Date: March 9, 2016

To: Development Commission

Subject: Briefing Response Memo for Gateway Senior Housing
Site Development Permit: SDP15-00005

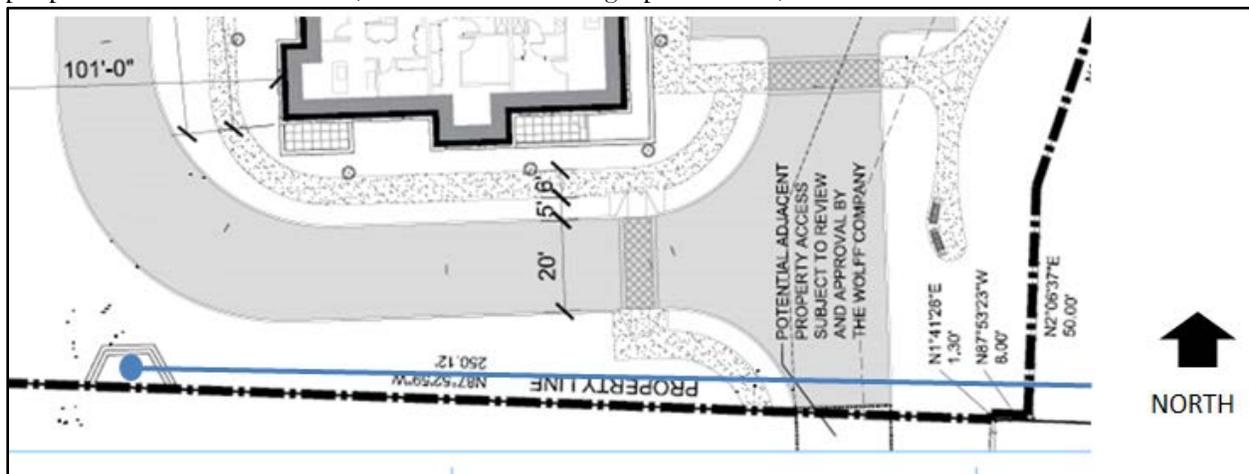
1. Vehicular connection to the abutting property immediately south of the project site (former veterinary clinic site): Can't see how the City can require the vet site to provide a street connection; requiring an access to the vet site from Newport Way will not be safe, given its close proximity to the roundabout. Why can't stairs be provided and retaining walls be adjusted at the access drive to accommodate a sidewalk at the north side of the neighborhood street?

The revised site plan shows a 6-foot wide sidewalk and 5-foot planter strip with street trees along the side closest to the building. Two new crosswalks are provided where a three-way intersection is now shown, with a road stub for a future connection to the former veterinary clinic site (now vacant). There is not a sidewalk at on the south side of the street. does not continue west, but rather it connects to the sidewalk closest to the building. In the future when the property to the south develops it will be determined as part of their land use permit review whether a sidewalk makes sense for their project or not. With the construction permits for Gateway Senior the City will determine if street trees can be placed on the south side of the street due to 30-inch storm line proposed in that same area (see blue line in the graphic below).

Staff: The Applicant has revised the site plan to show the Neighborhood Street extending along the south perimeter of the property to connect to the adjacent property to the south at the southeast corner (see Attachment 5, Revised Site Plan, Issue Date March 8, 2016). This location

Applicant: The location for a potential future vehicle connection to Newport Way from the Senior Housing site through the adjacent southern property will be identified on the site plan per City requirements. The configuration of the roadway on the adjacent property would need to be determined by that property owner as part of their site plan approval process, although it is not anticipated that it would impact the roundabout based on the current location of the driveway access to that property.
